TECHNICAL SERVICE BULLETIN

Subject	PowerTrain EEPROM Update
Issue Date	10/01/2025
Service Bulletin Number	SC-25-006
Models Affected	Service Specified Vehicles
Complete By	Next Service Opportunity
Labor Operation Code	HC60Z
Description	Powertrain EEPROM update to reduce cabin transmission noise and lower operating temperatures.

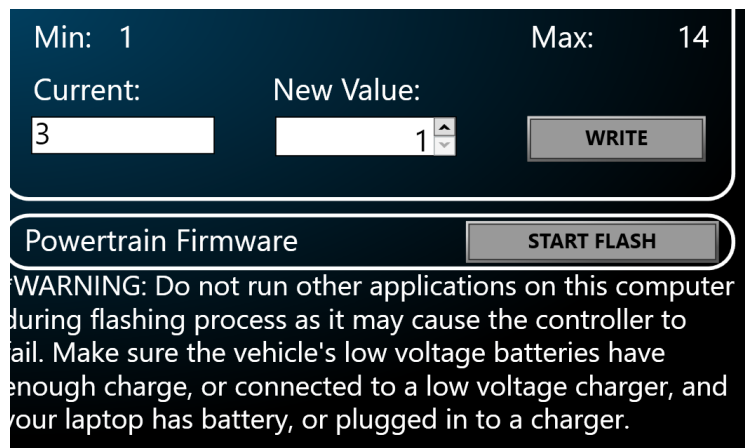
With the RNDL Configuration selected. Type in “1” in the new value field on the right hand side of the screen. And click “WRITE”.

Then a pop up will appear on the PDT, you must select “Ok” for the EEPROM to set.

Current: 3 New Value: 1

Power cycle the vehicle, and check to make sure the EEPROM set.
